1964 Corvette: Service Bulletin: 4-Speed Shift Lever Revision

Bulletin No: DR #691

Date: September 8, 1964

FIG. 2 - EARLY THREAD

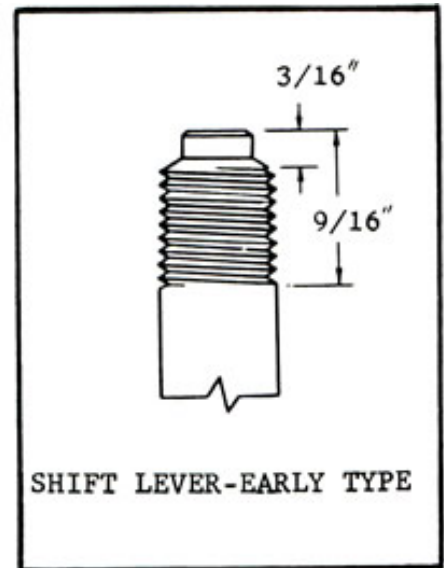
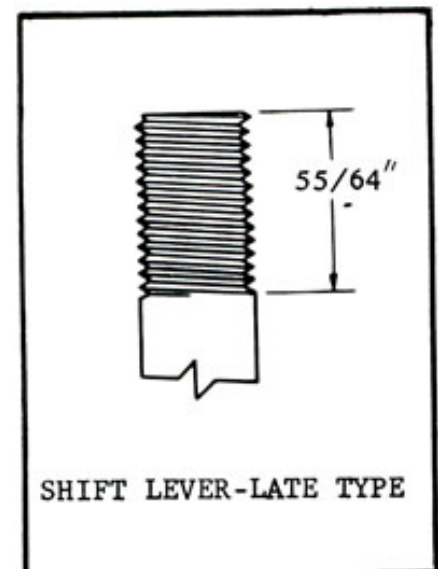
Two shifter knob designs and two shift lever thread designs have been used in 1964 production. The early design all plastic knob, part number 3846842, may be used on either lever. The late design knob, which has a threaded brass insert sleeve, can be used only on the late design lever. Refer to Figures 2 and 3 for details.

Regardless of lever or knob design, the threads must be free of burrs. The slot edges of the threads should be chamfered and smooth. When installing a knob, use extreme care to avoid cross-threading.

FIG. 4 - MODIFICATION OF SHIFT LEVER LOWER END

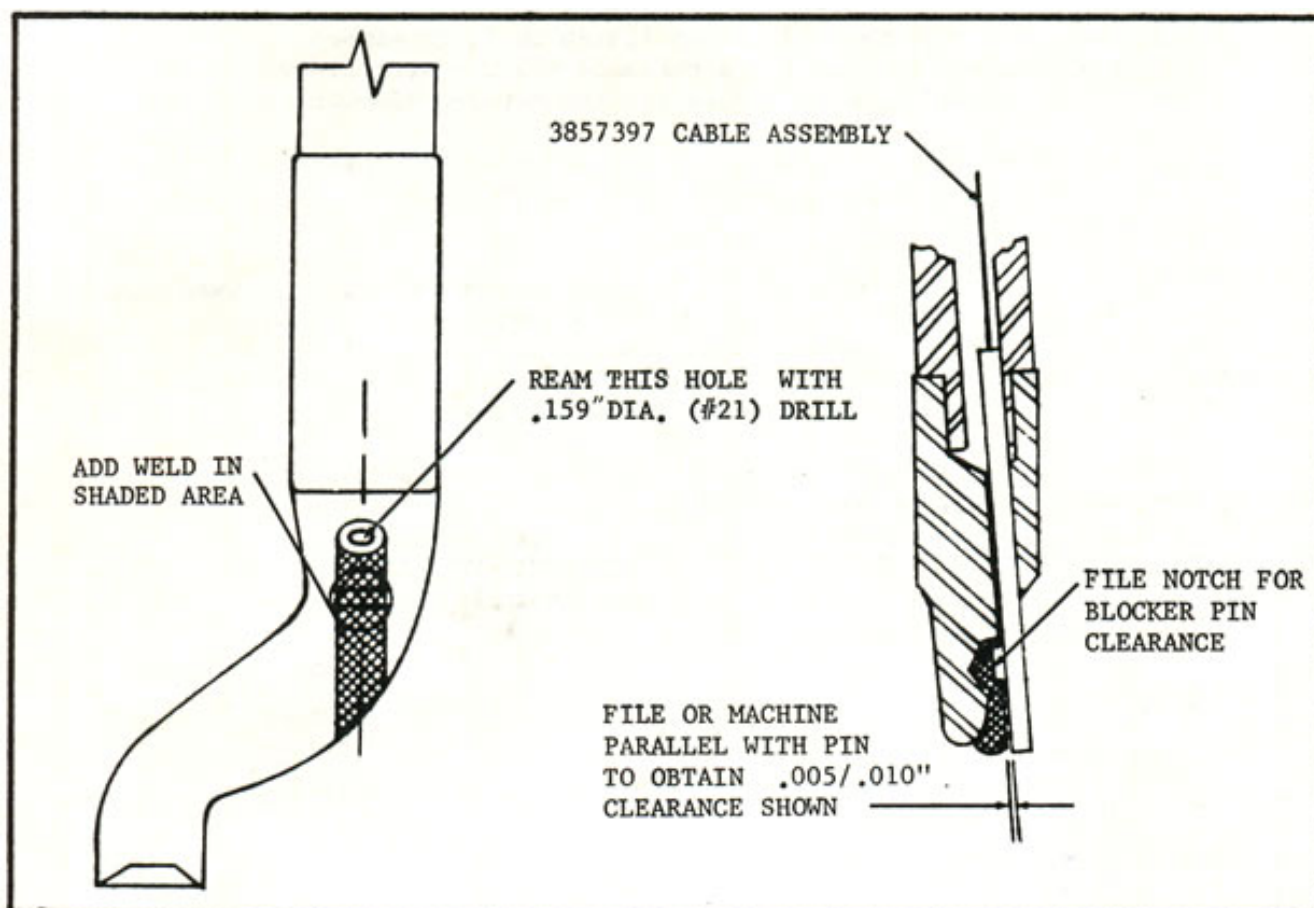
REVERSE INHIBITOR BINDS

2. Add a heavy weld or brass bead to the shift lever as shown by the shaded section of Figure 4.
3. File the bead flat and parallel to the reverse inhibitor pin with .005" to .010" clearance to the pin.
4. Remove and discard the pin and wire assembly from the "T" handle and enlarge the "T" handle hole to .082" with a 5/64" drill. Reassemble using the new pin and wire assembly, part number 3857397.

FIGURE 5 - REVERSE BLOCKER PIN LOCATING DETAILS

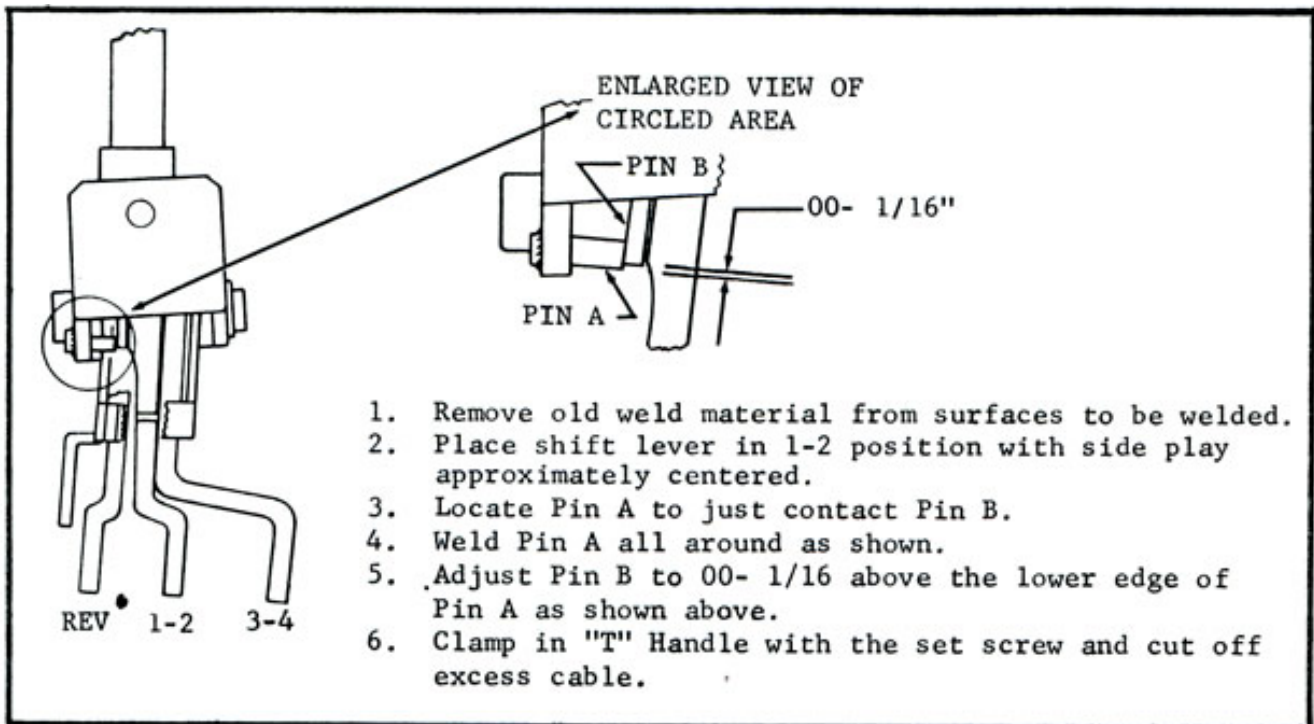
REVERSE BLOCKER PIN LOOSE OR MISSING

If the reverse blocker pin weld has broken, Figure 5 describes the proper locating dimensions for rewelding. If the original pin has been lost or damaged, a 1/4 inch by 5/8 inch hardened bolt, such as part no. 9409073, may

be used. The shift mechanism must be fully assembled before welding the pin so that the proper pin location may be achieved.
